**ISSUE:** Certificate of Appropriateness for Alterations and New Garage Construction

**LOCATION:** 917 Duke Street

**CASE BAR2012-0151**

PROPOSED SITE PLAN  
1" = 20'-0"

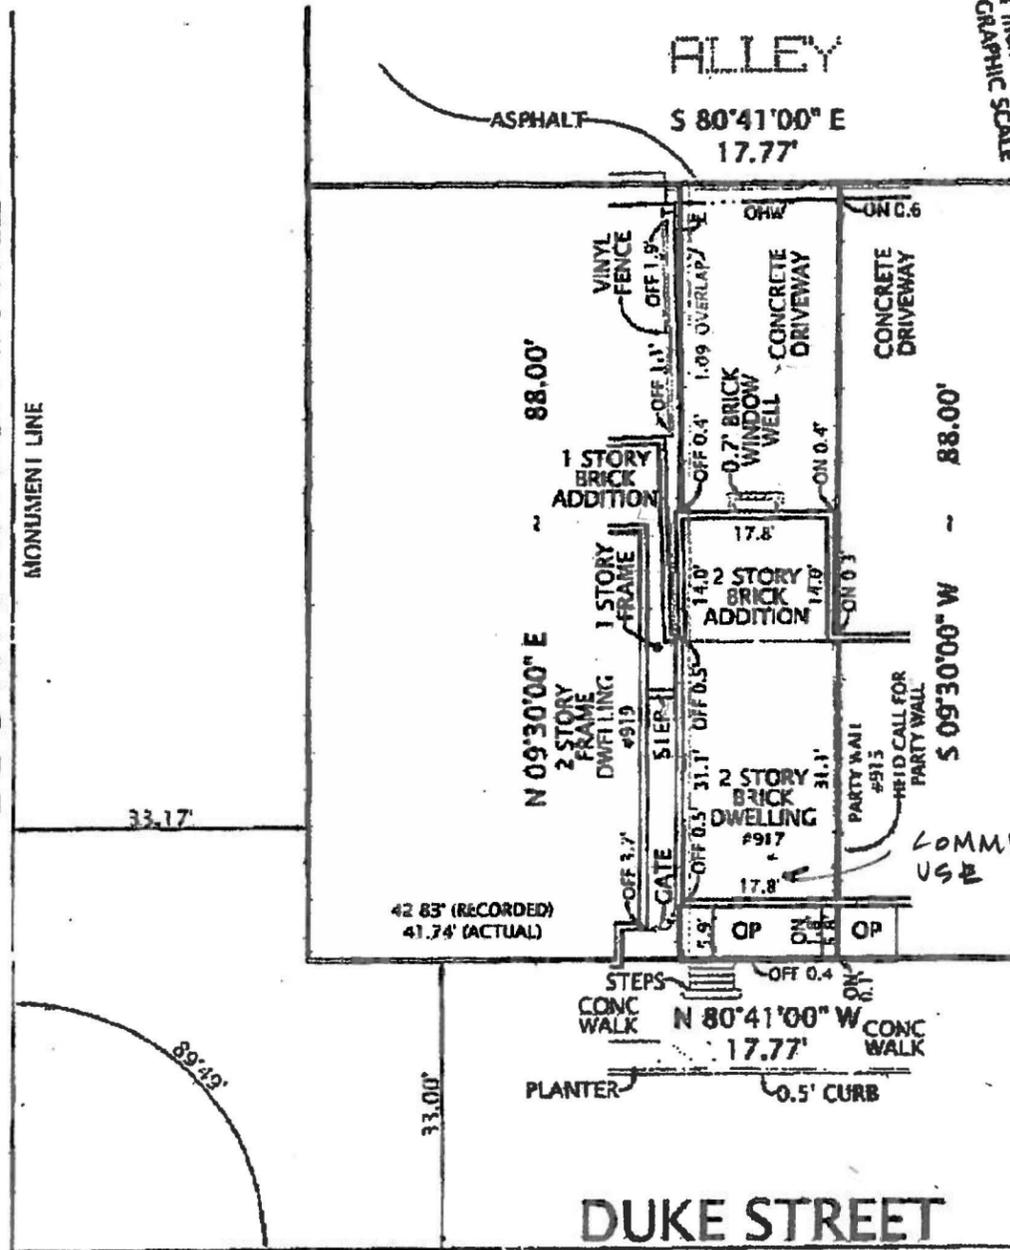
- F1. The physical presence of the garage will limit the overall maneuverability of vehicles compared to the existing site conditions. More information should be provided, to include the alley pavement width and the width of the garage door opening, to determine if acceptable turning movements into and out of the garage can be achieved. If the alley pavement width is less than 15 feet, turning movements should be provided to demonstrate acceptable ingress/egress into the garage can be achieved. (T&ES)
- F2. There shall be no parking within the alleyway at any time during construction or after the construction has been completed. (T&ES)

- F-1 The review by Code Administration is a preliminary review only. Once the applicant has filed for a building permit, code requirements will be based upon the building permit plans. If there are any questions, the applicant may contact Ken Granata, Acting Plan Review Supervisor at [ken.granata@alexandriava.gov](mailto:ken.granata@alexandriava.gov) or 703-746-4193.
- F-2 The plans indicate the garage exterior walls are built directly on the property line. Per the Virginia residential Code Section R302.1 (3) a roof eave cannot be larger than 4" and shall

not extend over the property line. If a gutter is installed as well, this width of the gutter shall also be considered from the property line in addition to the eave.

**Beautiful and Durable Western Red Cedar TYPE FLHD - FIXED LOUVER HEAVY DUTY Mortise & Tenon Construction**  
*A really tough shutter - All you will ever need!*

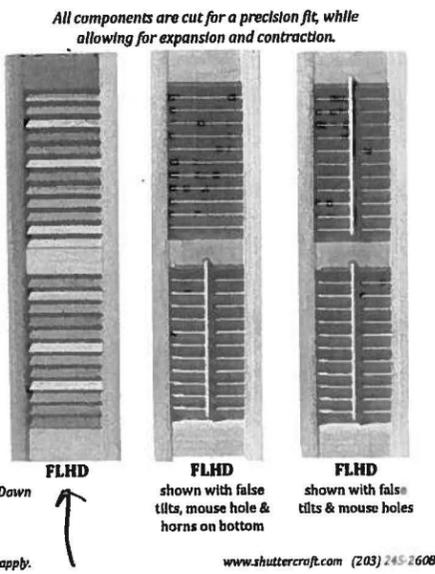
Staff finds no physical evidence of prior shutter hinge mortises in the existing window frames and was unable to locate BAR approval for the shutters on the adjacent properties at 913 and 915 Duke. However, an analysis of the building indicates that shutters could physically fit and be operable, in compliance with the *Design Guidelines*. While it appears that this row of simple Wardman-style rowhouses did not originally have shutters, they are appropriate to the period and

Staff supports the addition of louvered wood shutters to this property, as long as they are properly hinged and fit the openings.
